SB-GA8-2021-210

Service Bulletin

Flight Control Circuit Colour Coding

Figure 1 – Outboard Rudder Pedal Lever

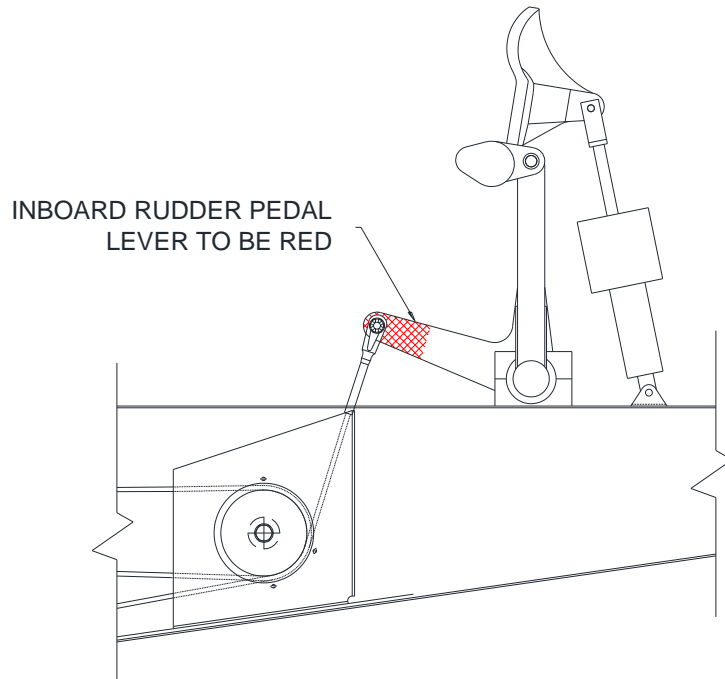
3. Paint the outboard rudder pedal lever with item 1 (YELLOW) as depicted in Figure 1. Avoid painting in proximity to the connection to the rudder cable. The paint should extend approximately two inches along the outboard rudder pedal lever. Ensure any incorrect colour coding is completely obscured or removed.

Figure 2 – Inboard Rudder Pedal Lever

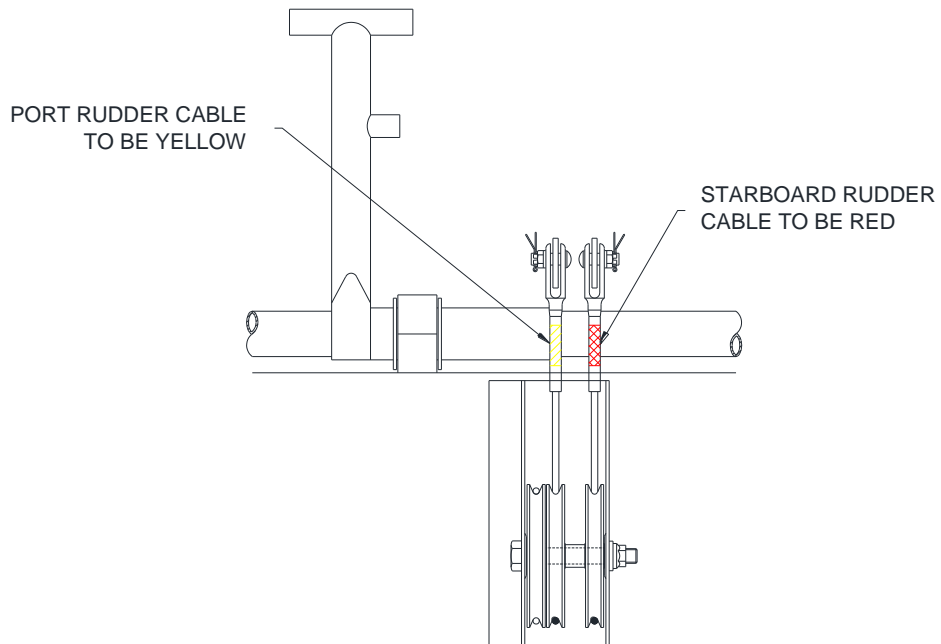
4. Paint the inboard rudder pedal lever with item 2 (RED) as depicted in Figure 2. Avoid painting in proximity to the connection to the rudder cable. The paint should extend approximately two inches along the outboard rudder pedal lever. Ensure any incorrect colour coding is completely obscured or removed.

Figure 4 – Bulkhead Assembly

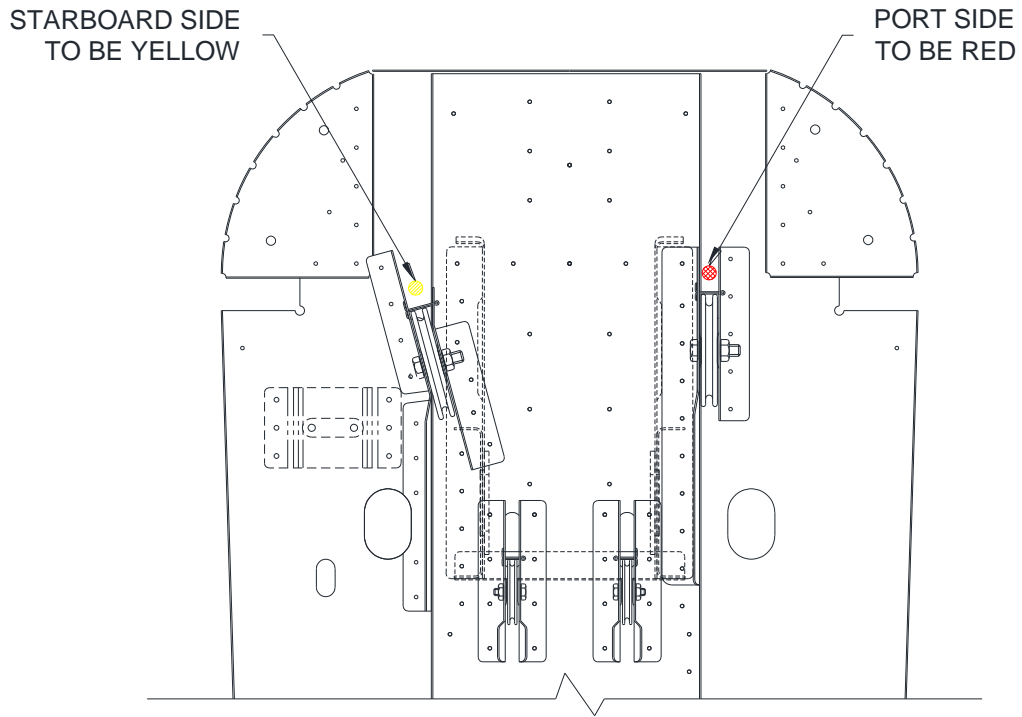
3. Place a small dot of paint of approximately 0.375" diameter using item 1 (YELLOW) above the upper starboard pulley and item 2 (RED) above the upper port pulley as illustrated in Figure 4. Ensure any incorrect colour coding is completely obscured or removed. Note that at the factory the colour coding is embodied as a small rectangular patch around the aperture which cannot be fully applied in the field due to the presence of the pulley brackets.

Figure 5 – Rudder Assembly (Starboard Side)

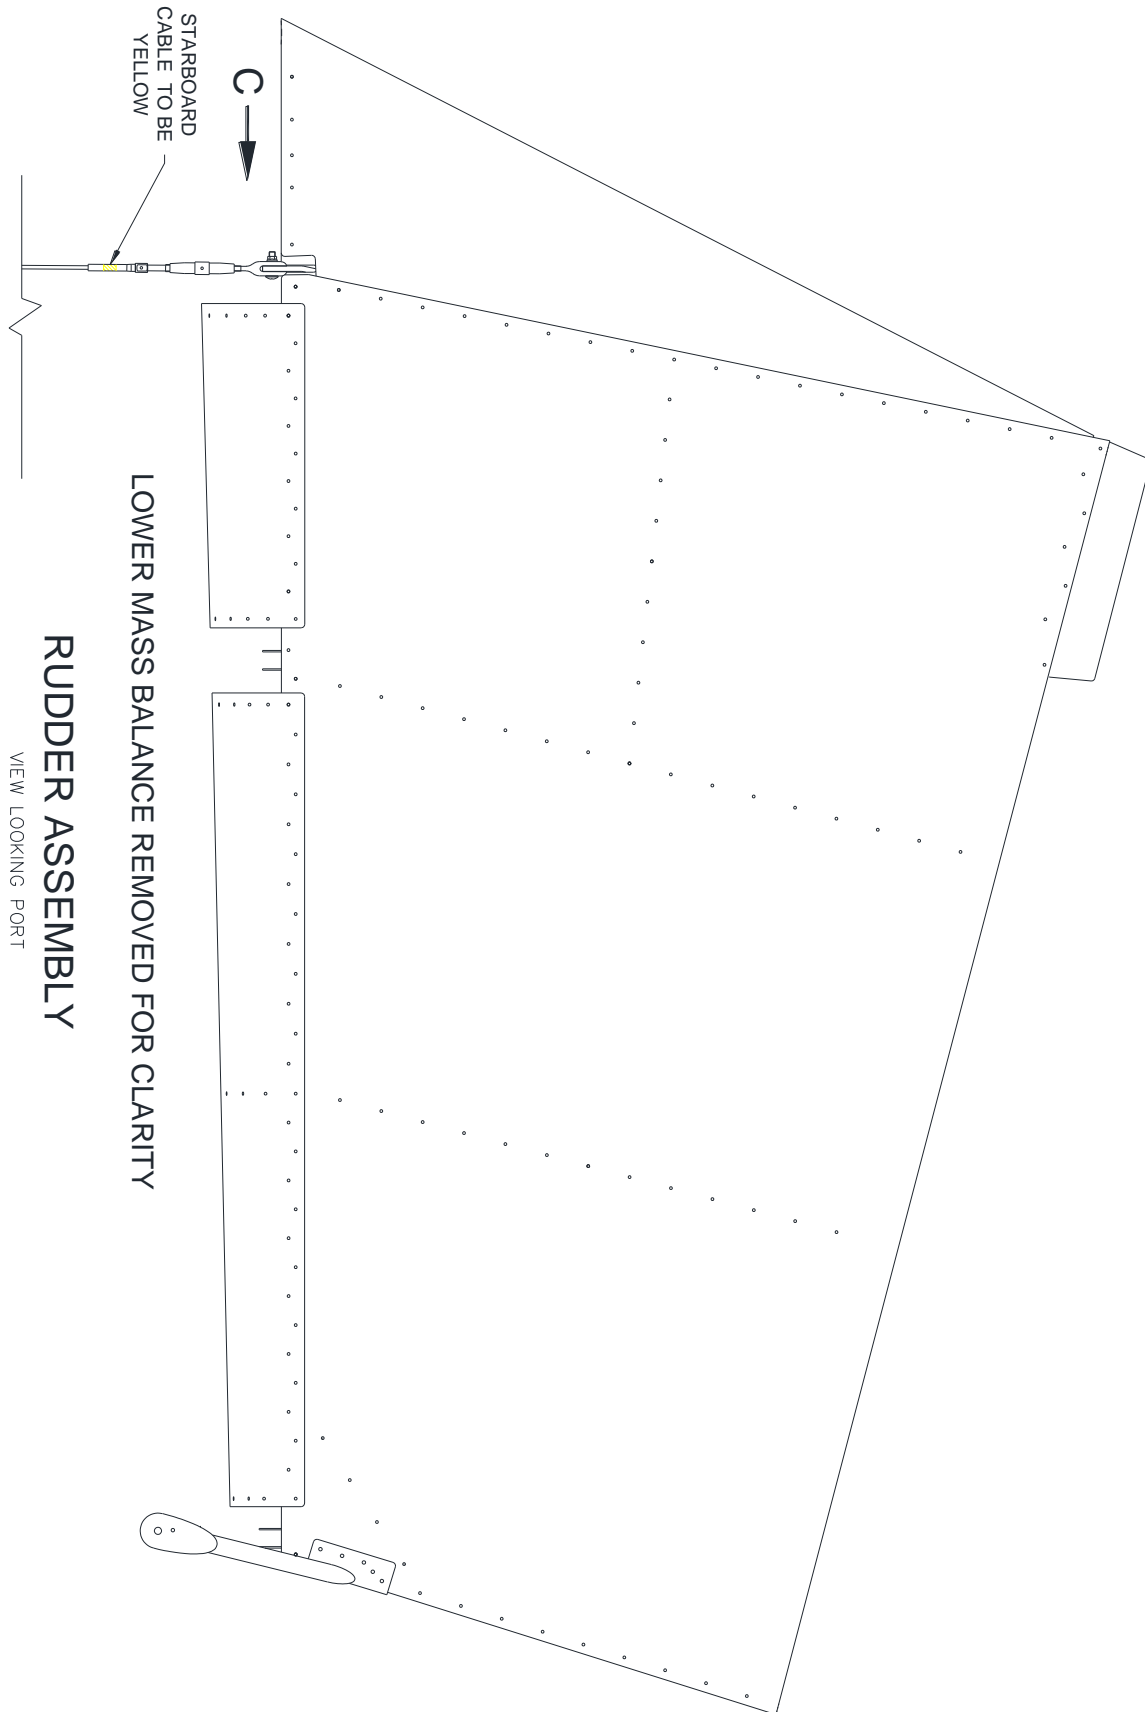
5. Apply the correct colour coding to the rear end of the rudder cable assemblies using item 1 (YELLOW) for the starboard cable and item 2 (RED) for the port cable as depicted in Figure 5 and Figure 6. Removing any fairings, as required. Ensure any incorrect colour coding is completely obscured or removed. The rudder cables may have plastic sleeves to provide the colour coding.

Figure 7 – Rudder Horn

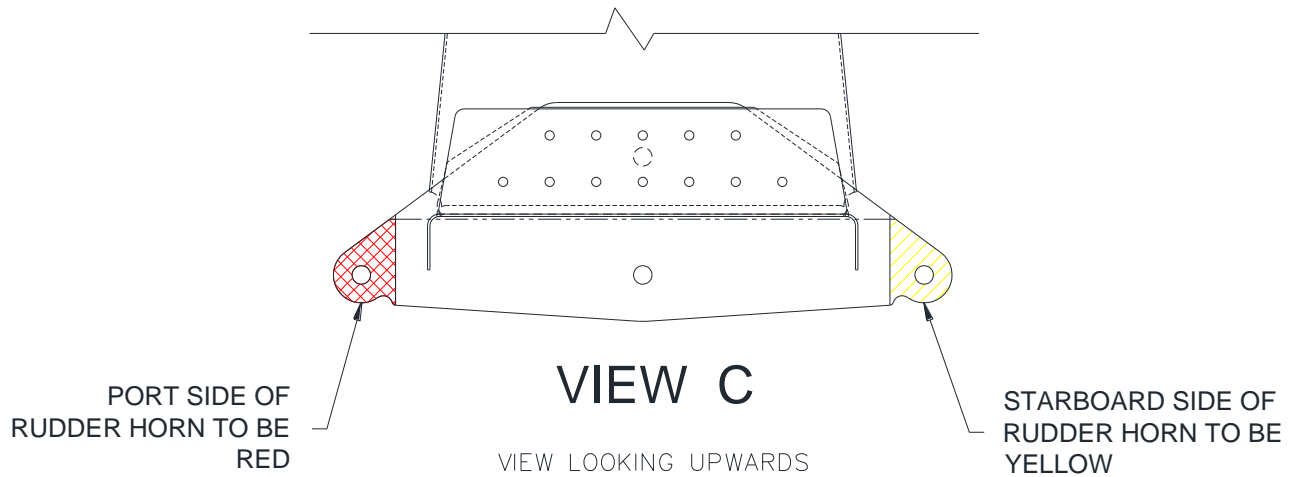
6. Apply colour coding to the rudder horn as illustrated in Figure 7. Removing any fairings, as required.
7. Re-install any removed fairings.

Figure 8 – Elevator Circuit (Forward)

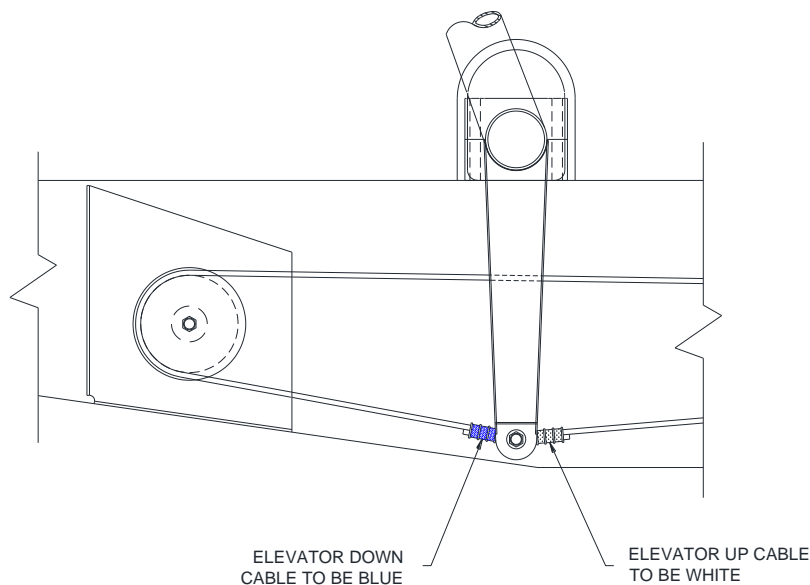
1. Remove the floor access panel adjacent to the control column to facilitate inspection of the forward end of the elevator cables.
2. Inspect the swaging on the elevator cables connected to the control column lever for correct colour coding. The elevator down cables routes forward and should be blue and the elevator up cable routes aft and should be white. If correct advance to step 4. Otherwise proceed with step 3.
3. Paint the elevator down cable swage with item 3 (BLUE) and the elevator up cable swage with item 4 (WHITE) as depicted in Figure 8. Ensure any incorrect colour coding is completely obscured or removed.
4. Re-install floor access panel with existing hardware, if serviceable.

Figure 9 – Elevator Circuit (Aft)

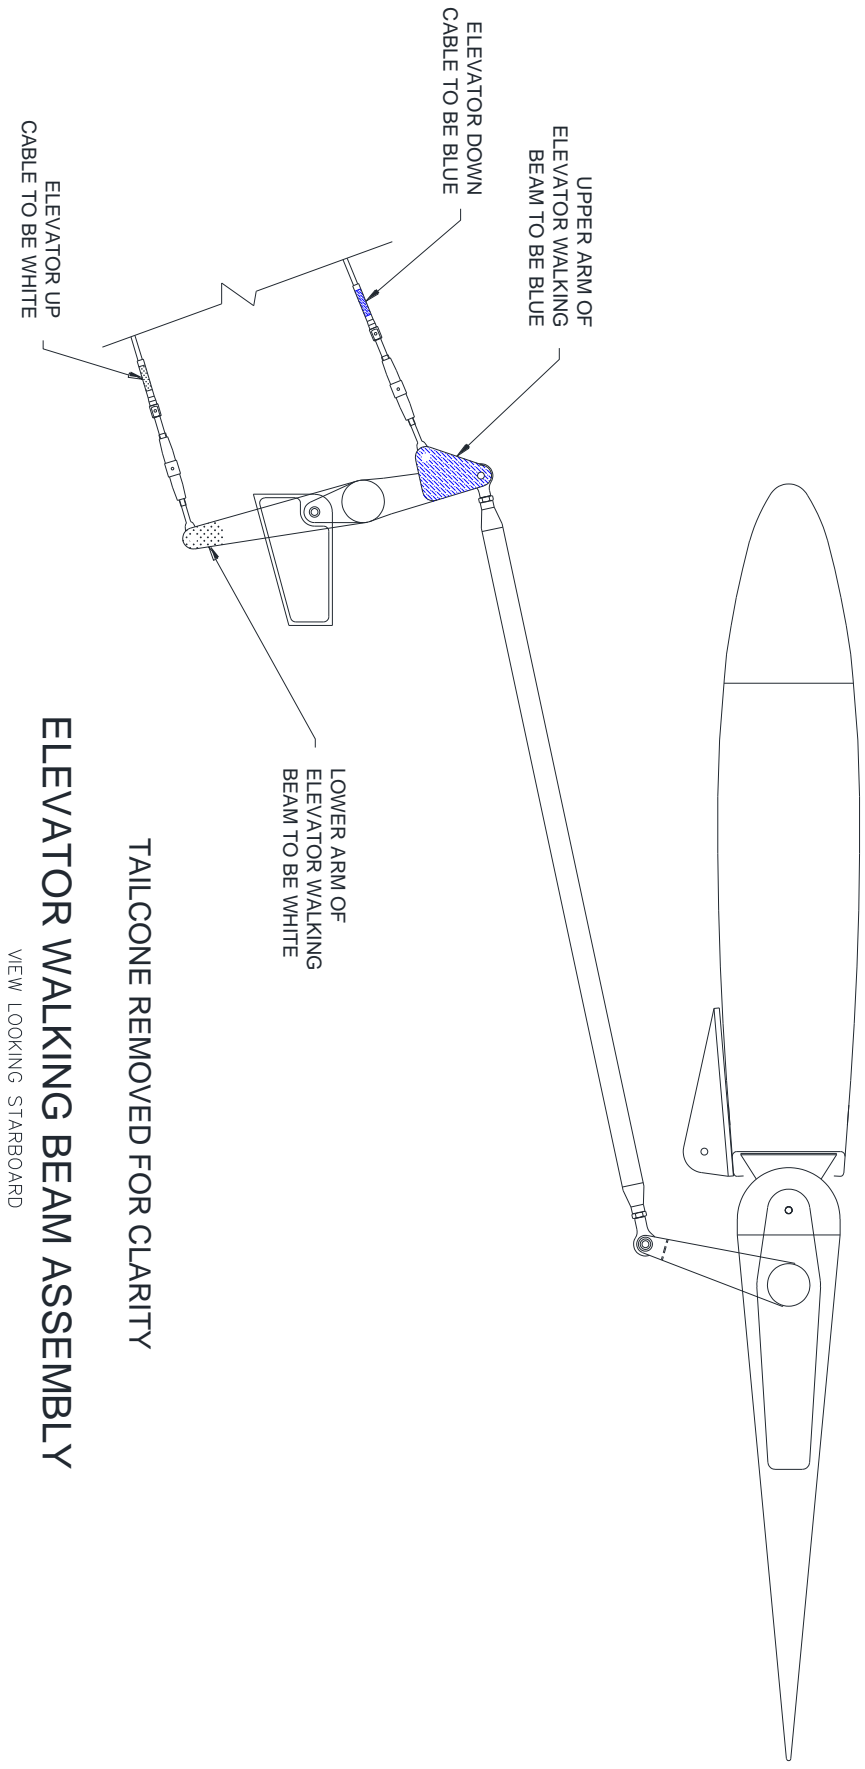
1. Inspect the elevator walking beam and cable assemblies. Check the elevator down cable and the upper arm of the walking beam are colour coded blue, and the elevator up cable and lower arm of the walking beam are white. If correct advance to step 3. Otherwise complete step 2.
2. Paint the swage on the elevator down cable and the lug on the upper arm of the elevator walking beam with item 3 (BLUE). Paint the swage on the elevator up cable and the lug on the lower arm of the elevator walking beam with item 4 (WHITE) as illustrated in Figure 9. Ensure any incorrect colour coding is completely obscured or removed.
3. Re-installed all removed access panels with existing hardware, if serviceable.
